Rezoning Transportation Analysis

Petition Number: Insert Zoning Petition # 2021-008

General Location Identifier: Tax ID 22120202

Revision Log:

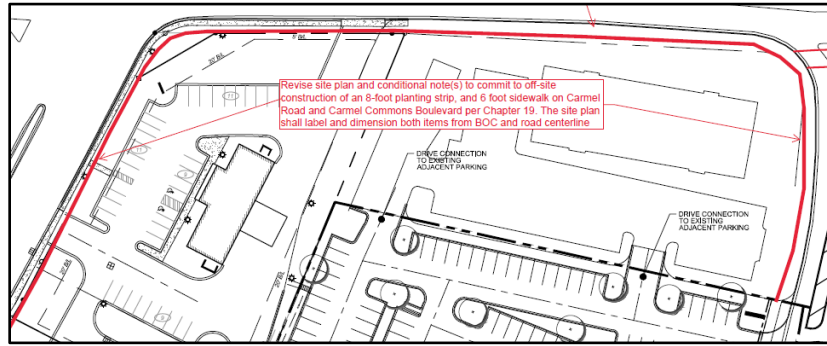
2. Traffic Study:

A Traffic Impact Study is necessary for the complete review of this petition due to the site generating more than 2,500 daily trips.

Staff will receive the petition and begin review, but the public hearing will not be scheduled until the TIS is approved to allow for the minimum time necessary for CDOT to review the study and reach agreement with the petitioner on the required transportation commitments. Any agreed upon commitments shall be included on the last site plan submitted no fewer than 4 weeks prior to the public hearing. Therefore, additional traffic mitigation comments may be forthcoming once the TIS is approved by CDOT (and NCDOT).

Updated to Comment as a Result of 04-12-2021 Site Plan: Pending approval of the TIS, the site plan and conditional notes will need to be revised to incorporate the established transportation improvements.

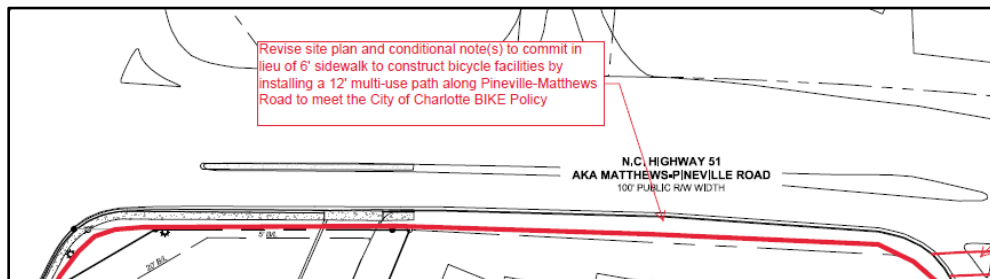
4. Revise site plan and conditional note(s) are needed to commit to installing an 8-foot planting strip and 6-foot sidewalk along Pineville-Matthews Road per Ch. 19, however, CDOT would prefer a 12-foot multi-use path allowing for a bicycle facility meeting the City Charlotte BIKE Policy.

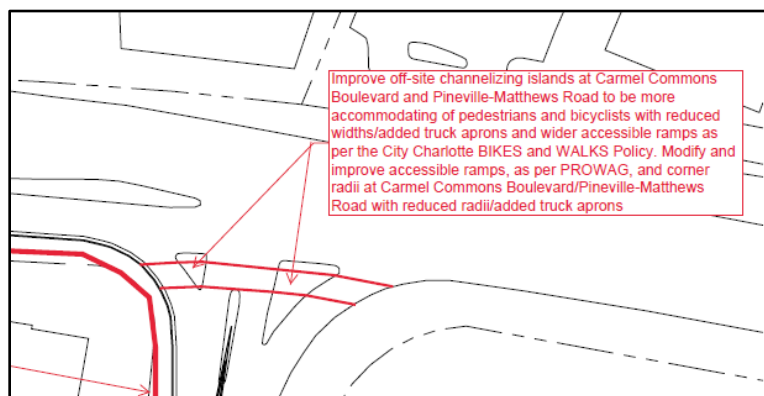
5. Revise site plan and conditional note(s) to commit to improve off-site channelizing islands at Carmel Commons Boulevard and Pineville-Matthews Road to be more accommodating of pedestrian and bicycles as per ADA/PROWAG, City of Charlotte WALKS and BIKES Policy. Modify and improve accessible ramps, as per PROWAG, and corner radii at Carmel Commons Boulevard/Pineville-Matthews Road with reduced radii/added truck aprons.

Updated to Comment as a Result of 04-12-2021 Site Plan: Revise the conditional notes by including a note committing to these ADA Improvements.

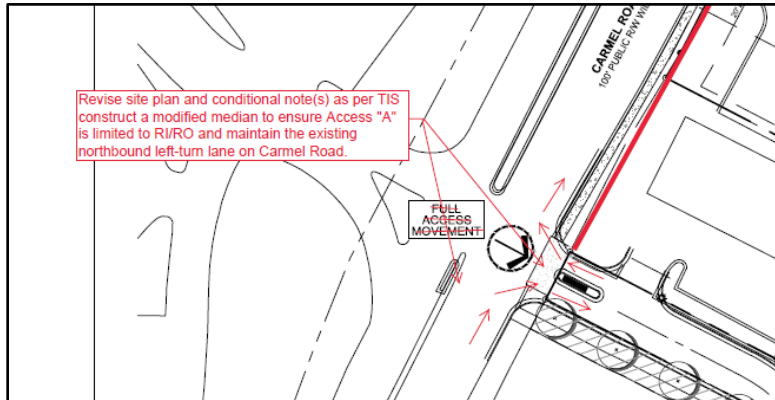
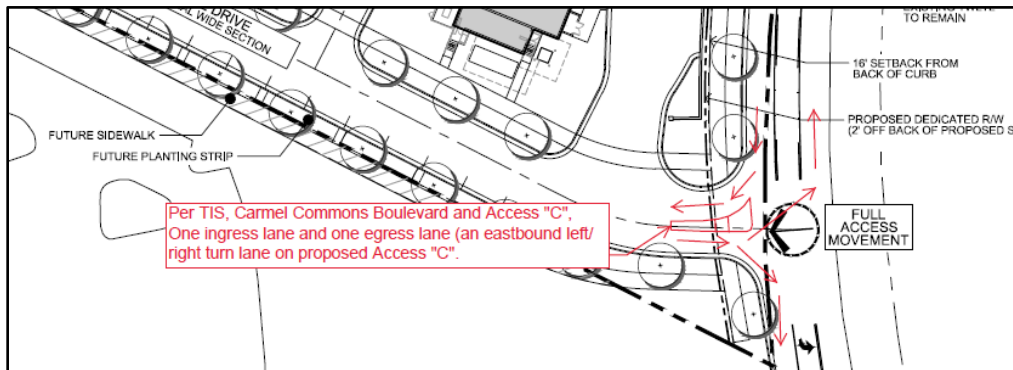
6. ~~Revise site plan and conditional note(s) per TIS report to construct a modified median to ensure Access "A" is limited to right in/right out (RIRO) and maintain the existing northbound left turn lane on Carmel Road. CDOT prefers constructing a directional crossover with raised concrete median islands.~~

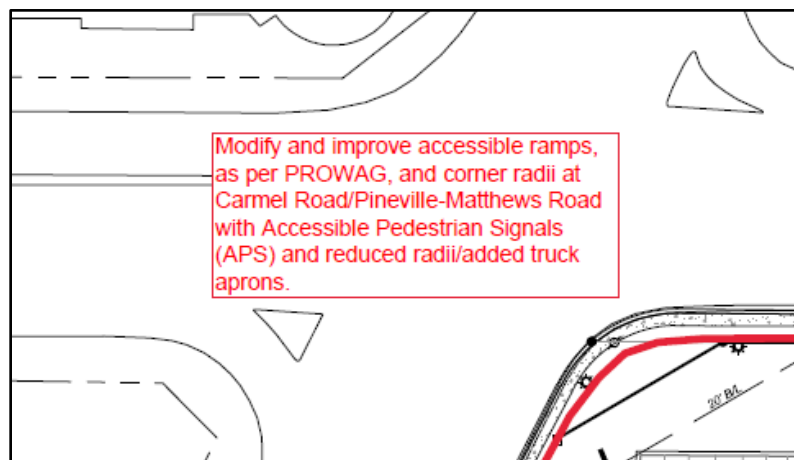
7. ~~Revise site plan and conditional note(s) per TIS report to show one ingress lane and one egress lane with an eastbound combined left/right turn lane on proposed Access "C" on Carmel Commons Boulevard. CDOT prefers the construction of a raised concrete median island or a pedestrian refuge to prevent prohibited movements.~~
